Access Compliance Report

Public Rights-of-Way

(Curb Ramps)

Intersection ID: 13871	Main Street: E_5TH_ST	Cross Street: HAWTHORNE_LN	Location: NW
ADA ID: 582A0D681F53	Ramp Type: Directional1	Initial Pass/Fail: Fail	Overall Compliance: No
		Severity Score: 35

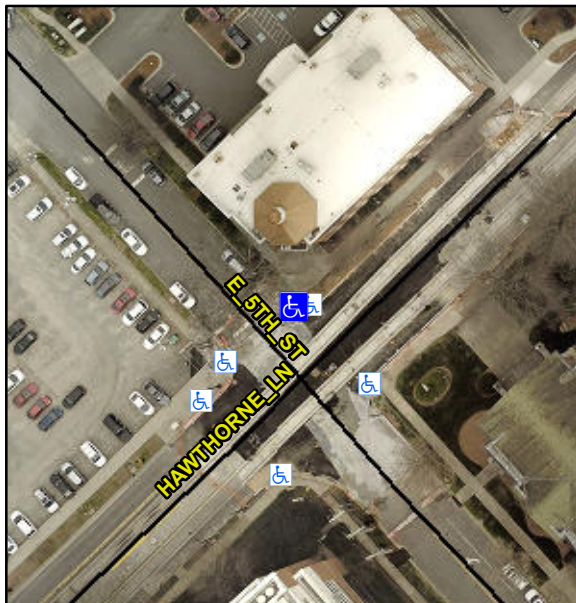
R304.5.1, R304.2.2, R304.5.3

Compliance	Description	Data	Compliance	Description	Data
N/A	Ramp Length (in)	54.5	N/A	Grade Break?	N/A
No	Ramp Width (in)	46.5	N/A	Grade Break Slope (%)	0.0
No	Ramp Slope (%)	12.1	N/A	Grade Break XSlope (%)	0.0
No	Ramp XSlope (%)	3.9			
N/A	Flare Type LT	N/A	N/A	Flare Type RT	N/A
N/A	Flare Slope LT (%)	N/A	N/A	Flare Slope RT (%)	0.0
N/A	Flare Traversable LT?	N/A	N/A	Flare Traversable RT?	N/A
N/A	Landing Length (in)	0.0	N/A	DWS Provided?	N/A
N/A	Landing Width (in)	0.0	N/A	DWS Contrast?	N/A
N/A	Landing Slope (%)	0.0	N/A	DWS Length (in)	N/A
N/A	Landing X Slope (%)	0.0	N/A	DWS Full Width?	N/A
N/A	Landing Curb? (Y/N)	N/A	N/A	DWS Offset LT (in)	N/A
N/A	Shared Landing?	N/A	N/A	DWS Offset RT (in)	N/A
N/A	Gutter Ponding?	0.0	N/A	Gutter Slope (%)	N/A
N/A	Gutter Lip Ht (in)	0.0	N/A	Gutter X Slope (%)	N/A
N/A	Painted X Walk1?	Yes		Road Slope (%)	3.2
	X Walk 1 Direction	To SW		Road X Slope (%)	3.2
	X Walk 1 Width (in)	113.0		Clear Space?	N/A

Remove & Replace Entire Ramp.
